TRAILS AT OVERLAND VISION FILING NO. 1

JR RESPONSE: UPDATED TO MATCH COA ITEM #4

TRAILS AT OVERLAND RANCH - SITE PLAN 1

2 3-RAIL CEDAR FENCE

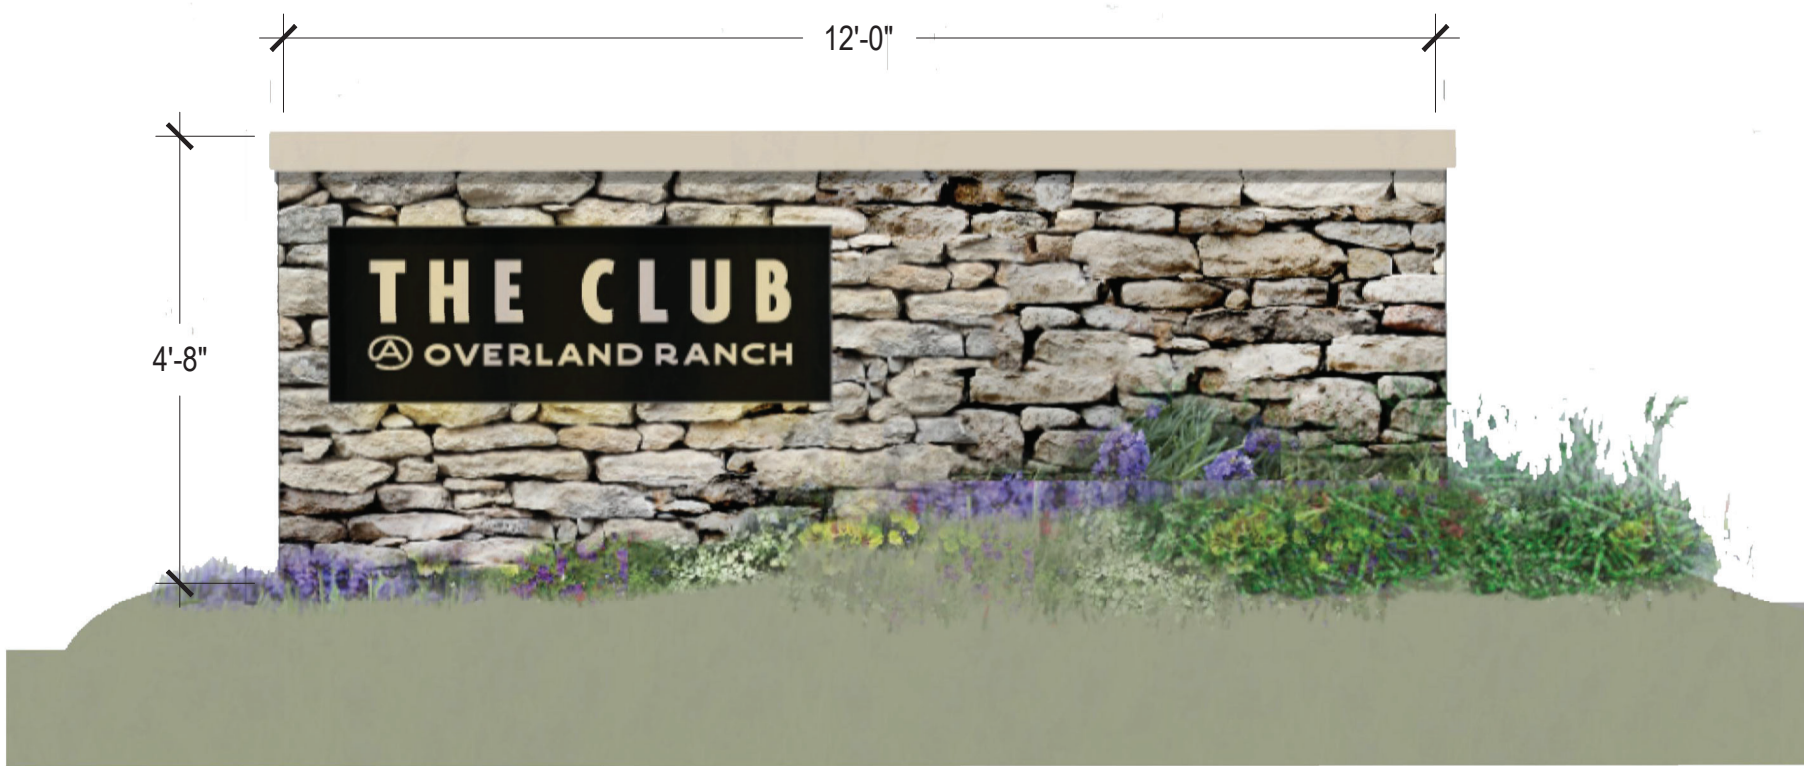
Can this sheet be updated to specify where the
open space fence detail on sheet 78 applies?
The fencing plan should be included somewhere
in the Site Plan. Carrying the fence symbology
throughout the landscape plan would also be
helpful for clarity.

FENCE WILL BE USED TO SEPARATE OPEN SPACE TRACTS FROM PRIVATE LOTS. REFER TO TRACT KEY MAP AND OPEN SPACE FENCING PLAN ON SHEET 52. -NORRIS DESIGN
